TENNESSEE VALLEY AUTHORITY  
DOCKET NO. 50-260  
BROWNS FERRY NUCLEAR PLANT, UNIT 2  
AMENDMENT TO FACILITY OPERATING LICENSE

Amendment No. 174  
License No. DPR-52

Attachment:  
Changes to the Technical  
Specifications

ATTACHMENT TO LICENSE AMENDMENT NO. 174

Figure 3.5.M-1  
BFN Power/Flow Stability Regions

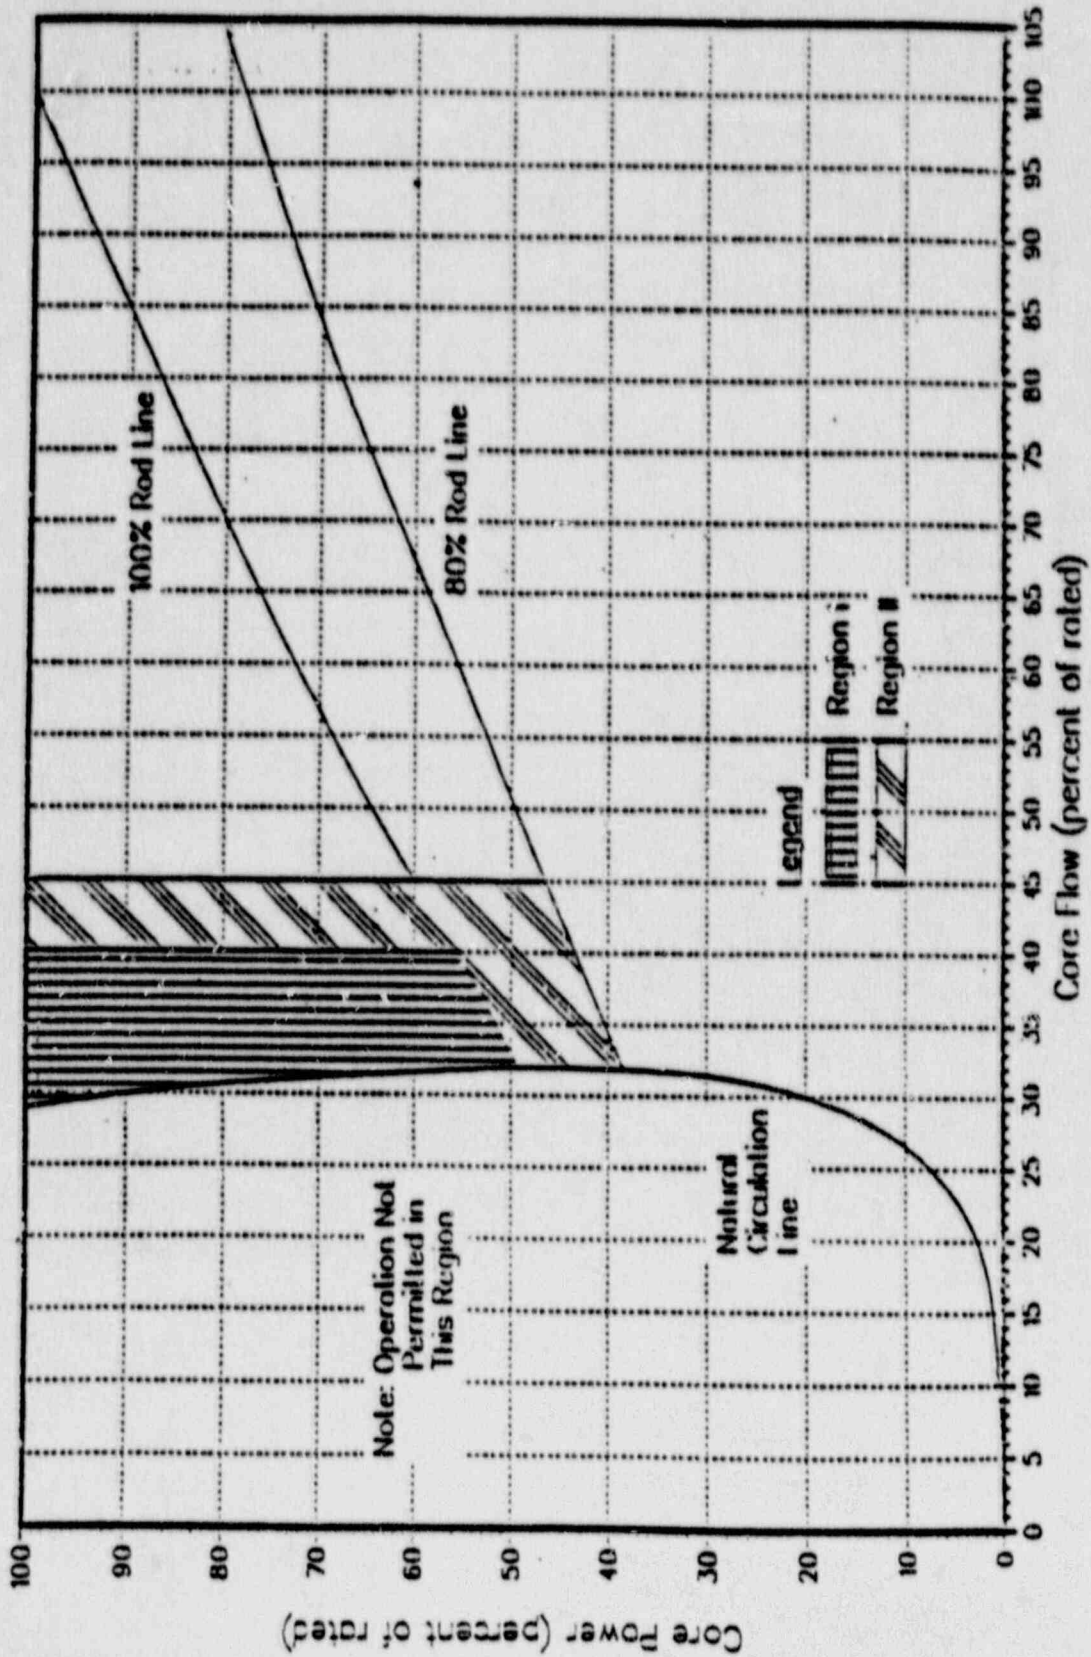
##### M. Core Thermal-Hydraulic Stability

1. The reactor shall not be operated at a thermal power and core flow inside of Regions I and II of Figure 3.5.M-1.
2. If Region I of Figure 3.5.M-1 is entered, immediately initiate a manual scram.
3. If Region II of Figure 3.5.M-1 is entered:

1. Verify that the reactor is outside of Region I and II of Figure 3.5.M-1:
  - a. Following any increase of more than 5% rated thermal power while initial core flow is less than 45% of rated, and
  - b. Following any decrease of more than 10% rated core flow while initial thermal power is greater than 40% of rated.

- a. Immediately initiate action and exit the region within 2 hours by inserting control rods or by increasing core flow (starting a recirculation pump to exit the region is not an appropriate action), and
- b. While exiting the region, immediately initiate a manual scram if thermal-hydraulic instability is observed, as evidenced by APEM oscillations which exceed 10 percent peak-to-peak of rated or LPEM oscillations which exceed 30 percent peak-to-peak of scale. If periodic LPEM upscale or downscale alarms occur, immediately check the APEM's and individual LPEM's for evidence of thermal-hydraulic instability.

The minimum margin to the onset of thermal-hydraulic instability occurs in Region I of Figure 3.5.M-1. A manually initiated scram upon entry into this region is sufficient to preclude core oscillations which could challenge the MCPR safety limit.

Because the probability of thermal-hydraulic oscillations is lower and the margin to the MCPR safety limit is greater in Region II than in Region I of figure 3.5.M-1, an immediate scram upon entry into the region is not necessary. However, in order to minimize the probability of core instability following entry into Region II, the operator will take immediate action to exit the region. Although formal surveillances are not performed while exiting Region II (delaying exit for surveillances is undesirable), an immediate manual scram will be initiated if evidence of thermal-hydraulic instability is observed.

Clear indications of thermal-hydraulic instability are APEM oscillations which exceed 10 percent peak-to-peak or LPEM oscillations which exceed 30 percent peak-to-peak (approximately equivalent to APEM oscillations of 10 percent during regional oscillations). Periodic LPEM upscale or downscale alarms may also be indicators of thermal hydraulic instability and will be immediately investigated.

During regional oscillations, the safety limit MCPR is not approached until APEM oscillations are 30 percent peak-to-peak or larger in magnitude. In addition, periodic upscale or downscale LPEM alarms will occur before regional oscillations are large enough to threaten the MCPR safety limit. Therefore, the criteria for initiating a manual scram described in the preceding paragraph are sufficient to ensure that the MCPR safety limit will not be violated in the event that core oscillations initiate while exiting Region II.
